Service Bulletin

Product: Dual Stage Snow Throwers, 200 series only

We have received reports of the engine pulley bolt backing out of the engine crankshaft. The engine pulley could become loose or detached from the engine. Damage to the drive belt is possible if this occurs. This bulletin describes how to install a longer engine pulley bolt.

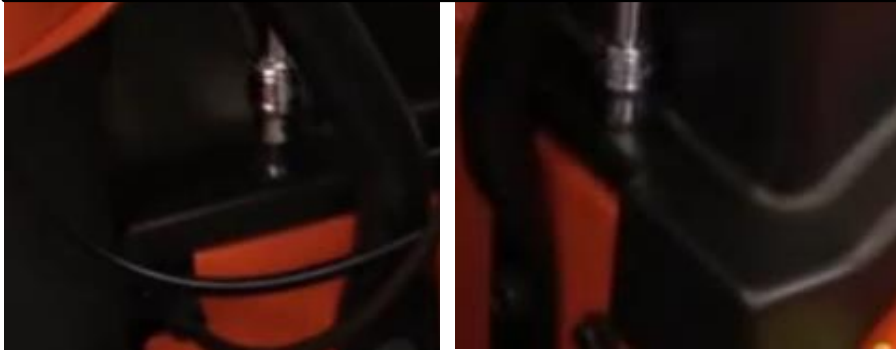
Old engine pulley bolt part number: 532179617
New engine pulley bolt part number: 532191760*

3. Remove engine pulley bolt and install new bolt. Also install washer if specified on page 2. Torque 40-55 ft-lbs to tighten bolt.
